Transmission Oil Cooler Lines Rubbing APU Coolant Lines

- Gen 5 Cascadia WST 47x 49x

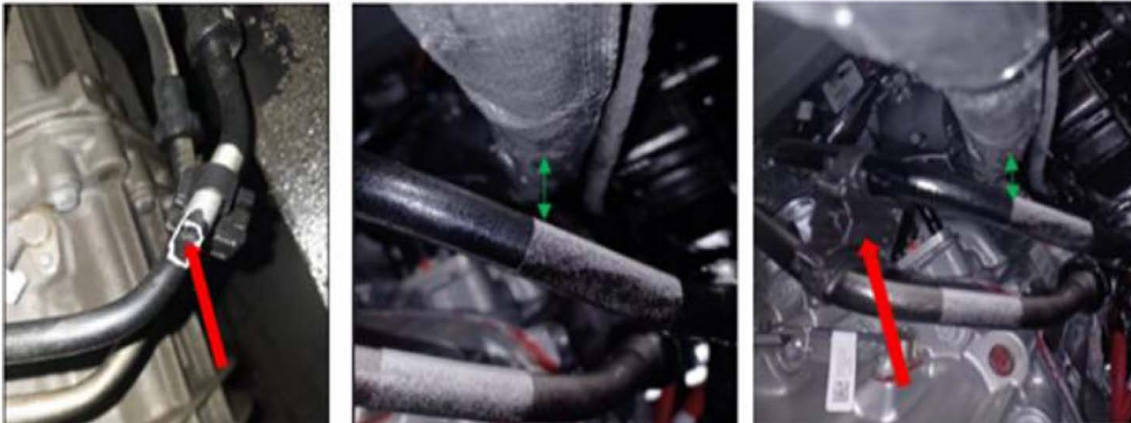
- Nylon Transmission oil cooler lines if not fastened correct can rub & chafe & eventually leak at low mileage. If caught early, lines are replaced. If not caught quickly the entire transmission often must be replaced.

- Plant Work instruction was updated to address the routing requirements, Stating not to deviate or add any extra ties or clamps.
- Re-Training at the plants per the updated work instruction implemented & ongoing.

- LTCA Production – Plant Updates – Add Transmission Cooler lines to Standard Routing and Clipping Guidelines.
- Verification 30/60/90 Day process audits to be complete by 7/30/26
